**1.1 ADDENDUM FORM**

- .1 This Addendum forms part of the Contract Documents and modifies the Bidding Documents dated August 20, 2018, with amendments and additions noted below.
- .2 Acknowledge receipt of this Addendum in the space provided in the Bid Form. Failure to do so may disqualify the Bidder at the Owner's discretion.
- .3 This addendum consists of six (6) pages plus the following list of attached drawings:

PROJECT INTERIOR RENOVATIONS  
 CONTENTS REVISED PHASING PLAN

CLIENT FEDERAL BUILDING

**3** NEW PARTIAL ROOF POWER PLAN  
E2R1B 1:100

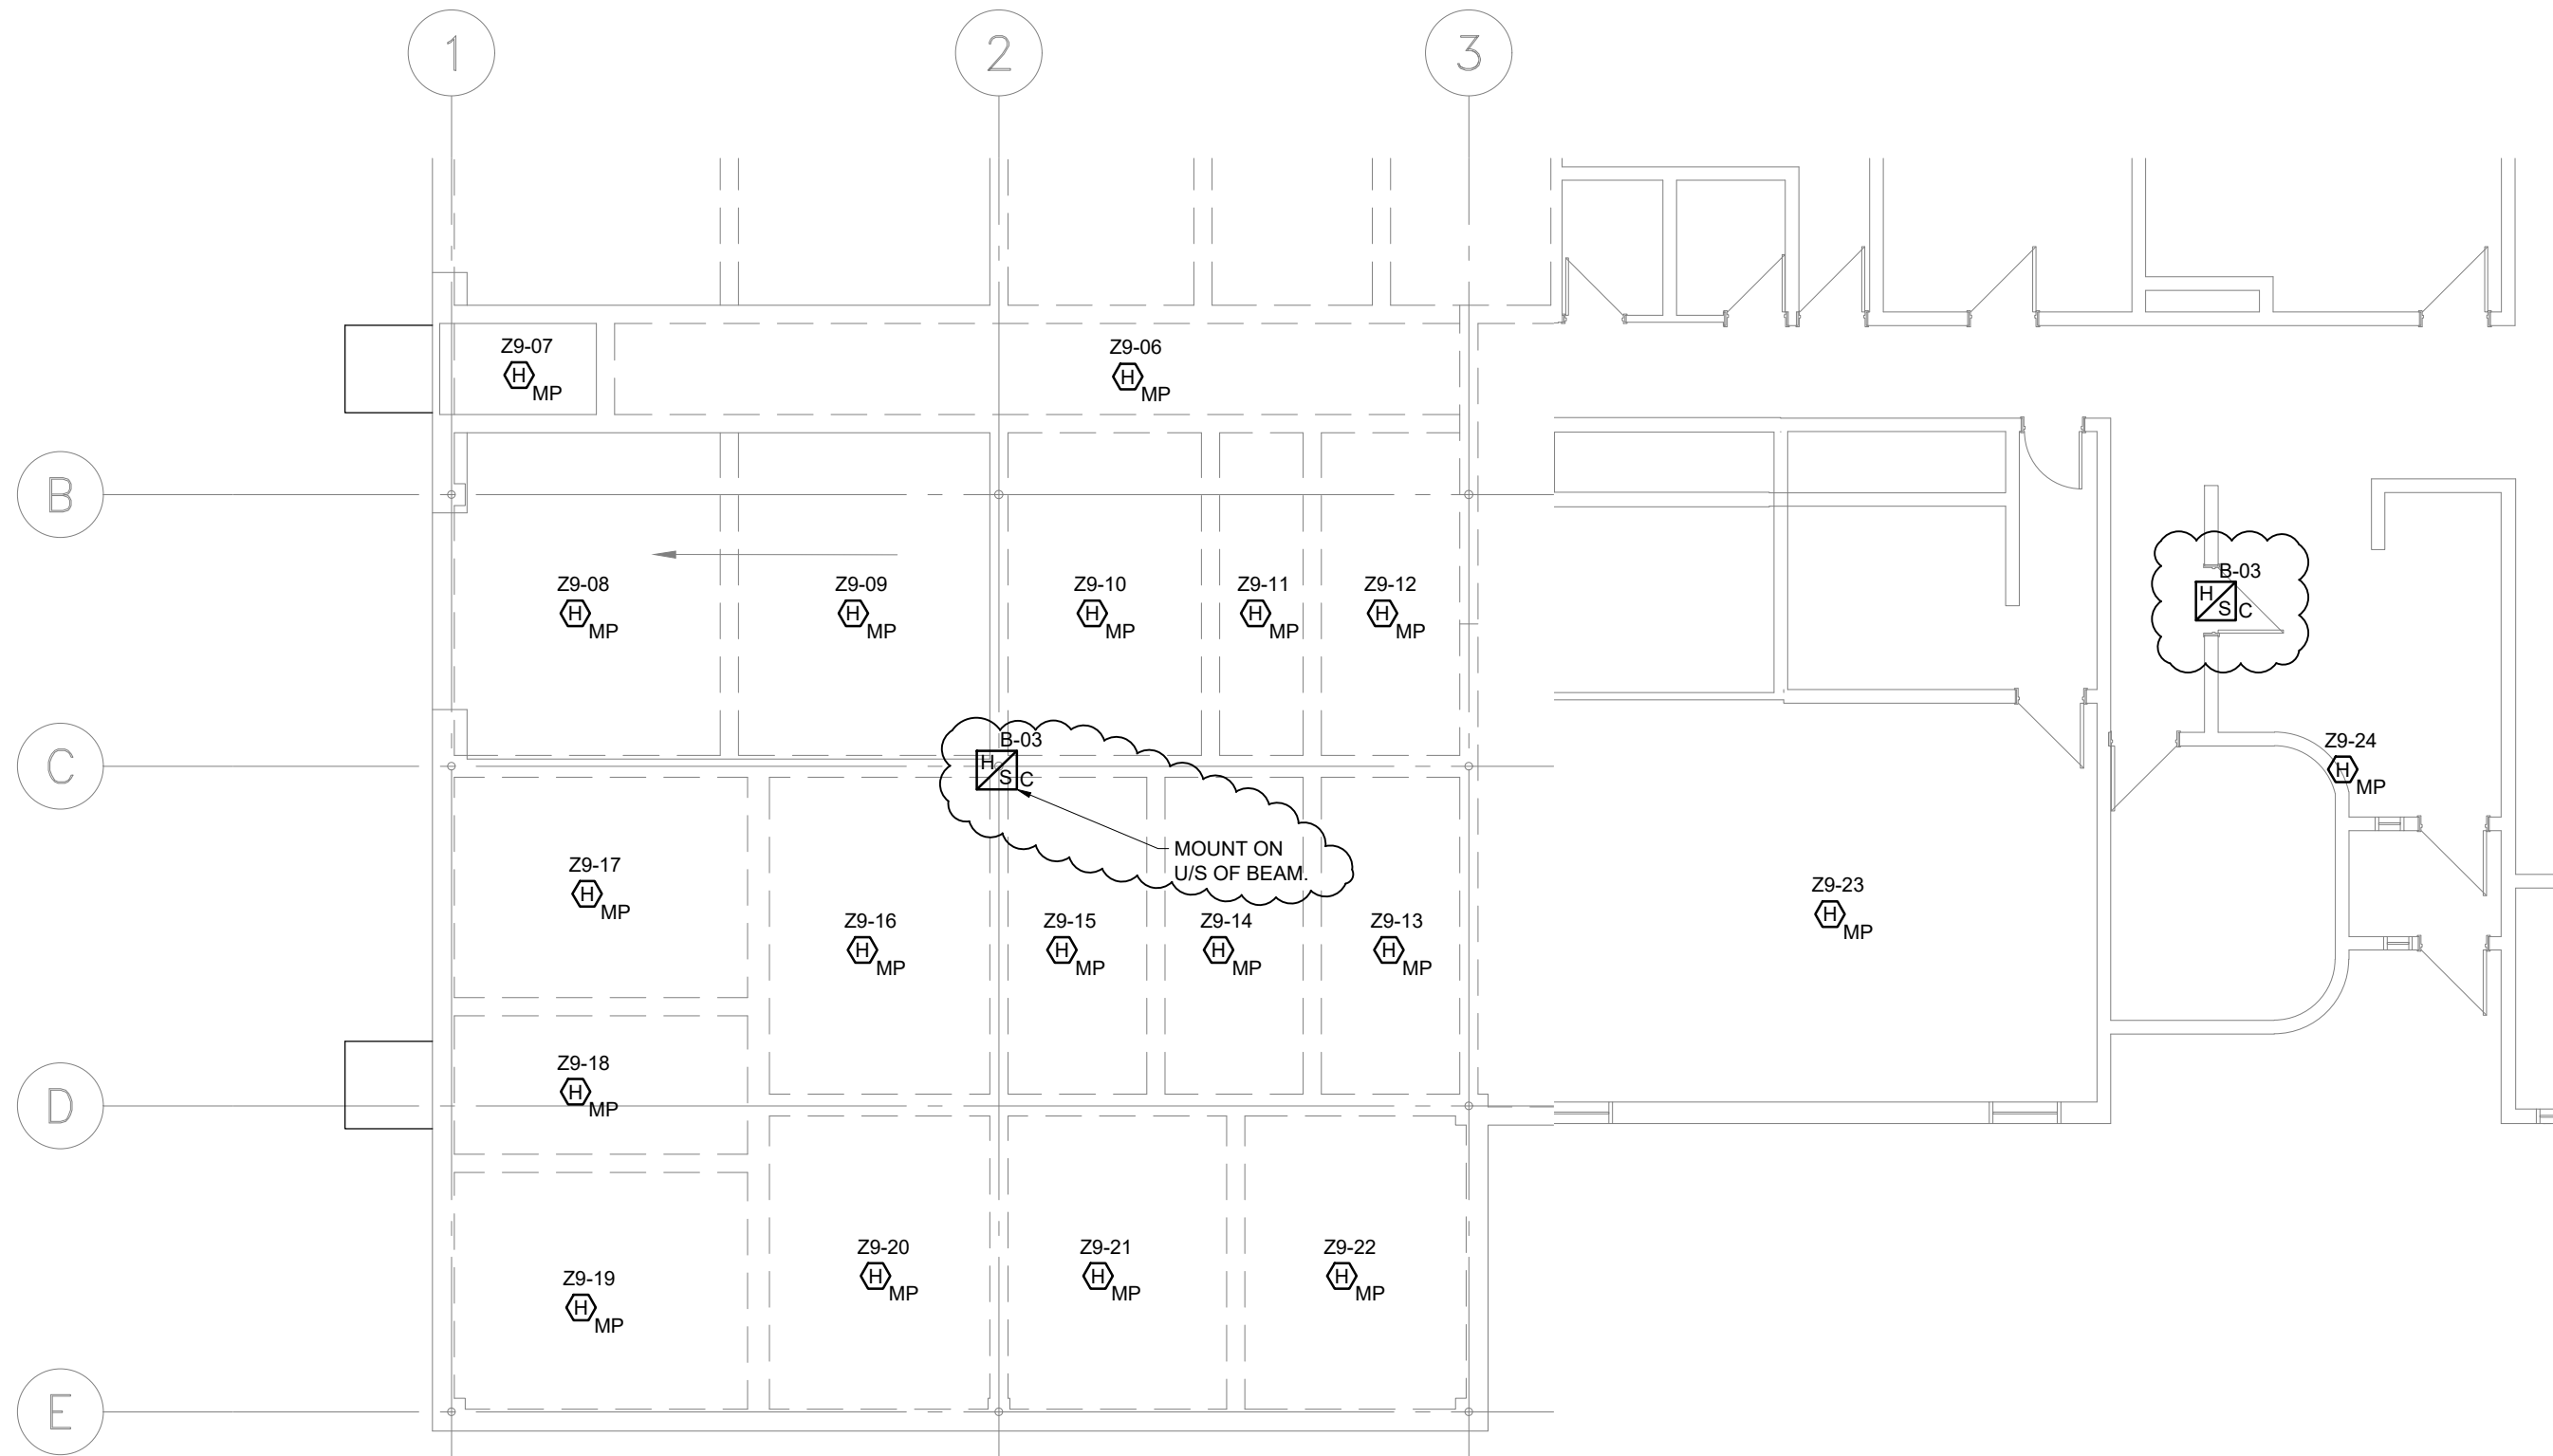
- .6 DRAWING M3R1 – Mechanical Schedules
  - .1 **Revise** schedule.
- .7 DRAWINGS E2R1A, E2R1B, E3R1A, E3R1B, E4R1, E5R1A, E5R1B, E6R1
  - .1 **Revise** controls of SF-1 and EF-9.

- .2 **Add** new exhaust fan EF-10.

**1 CRAWLSPACE FIRE ALARM SYSTEMS PLAN**  
 E3R1A 1:100

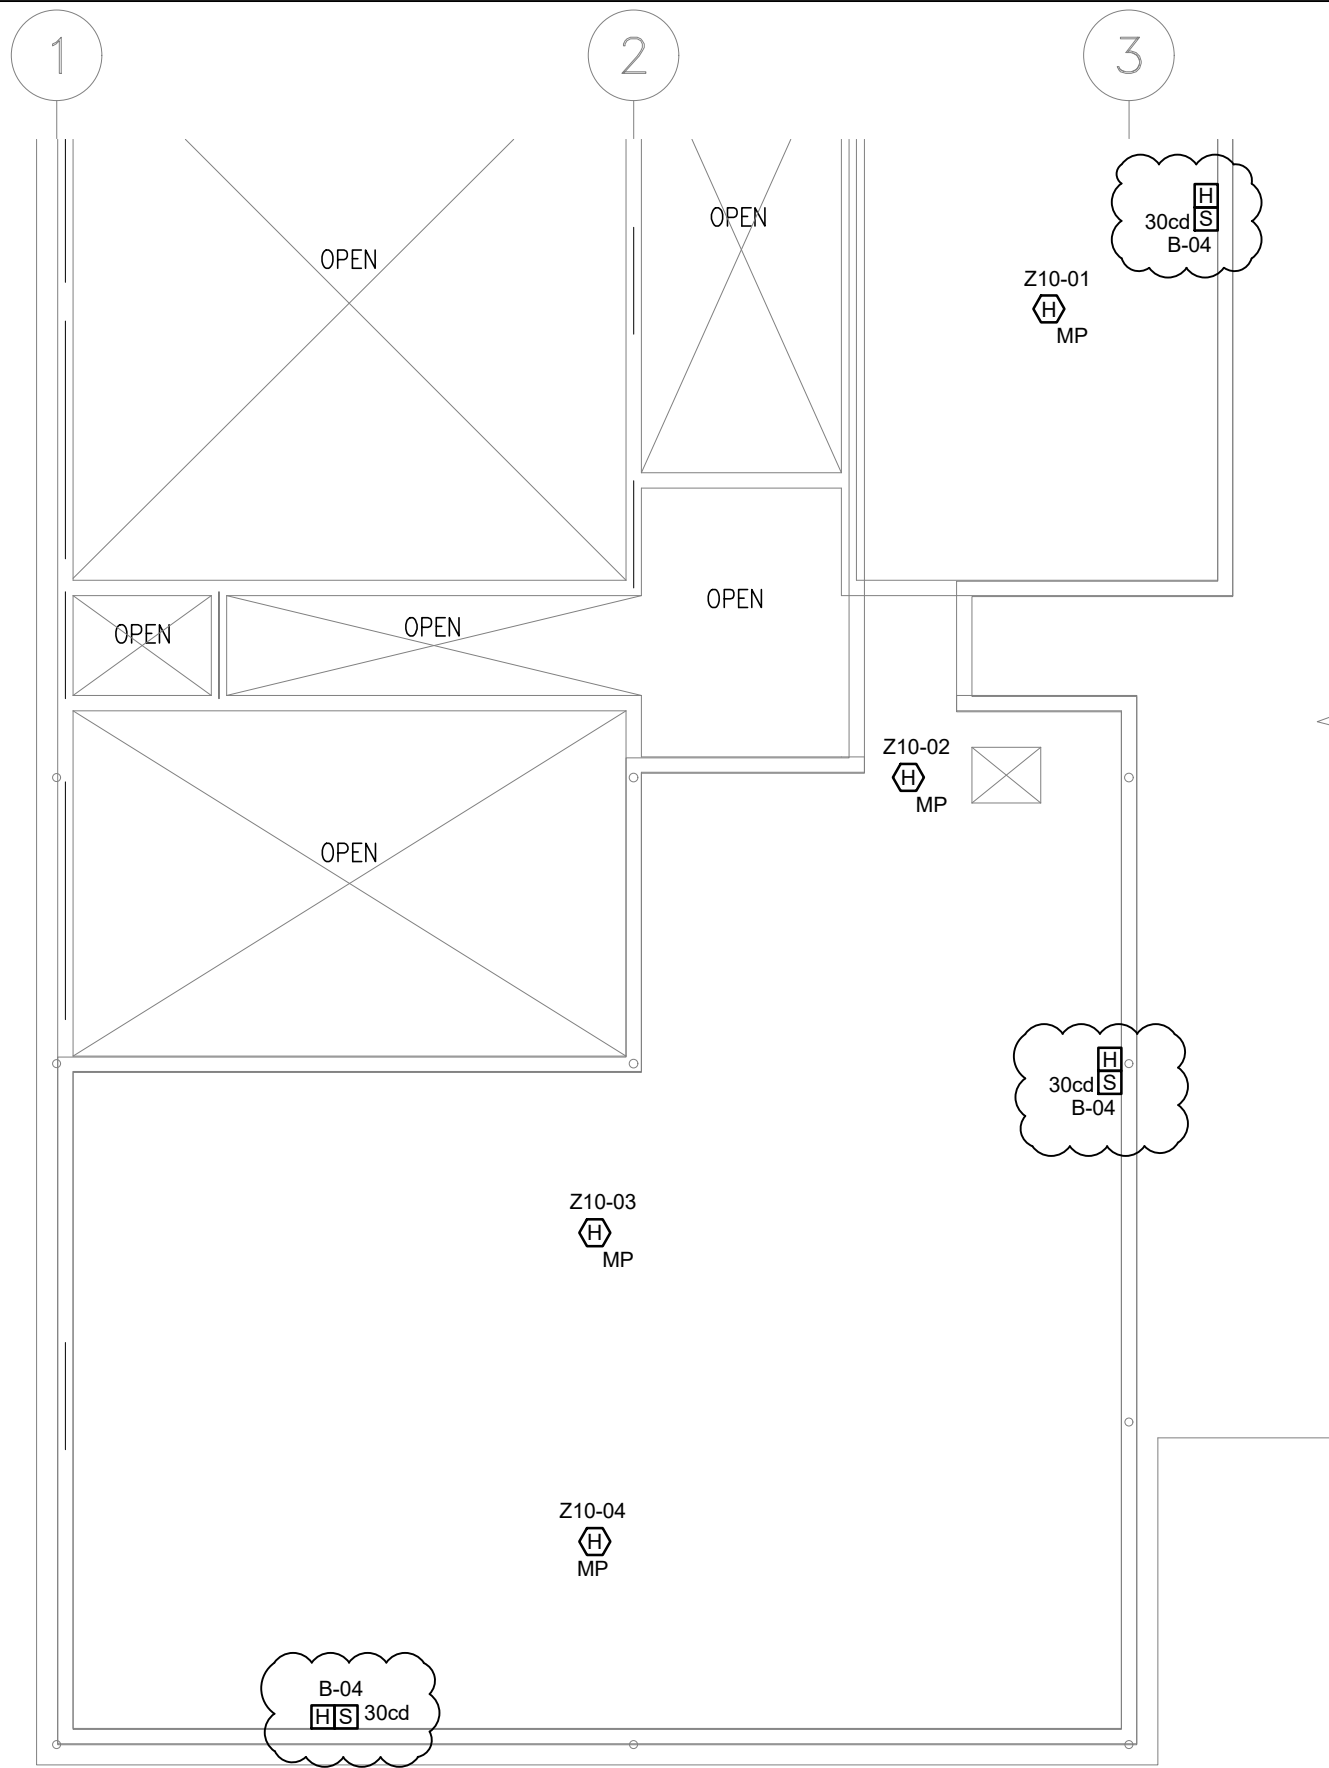
- .3 **Provide** interconnection to new fire / smoke dampers.
- .4 **Add** new horn / strobes in crawlspace and attic
- .5 **Provide** fire alarm fan shutdown for EF-9, EF-10 and RTU-1.
- .6 **Provide** independent supervisory zone for carbon monoxide detector.
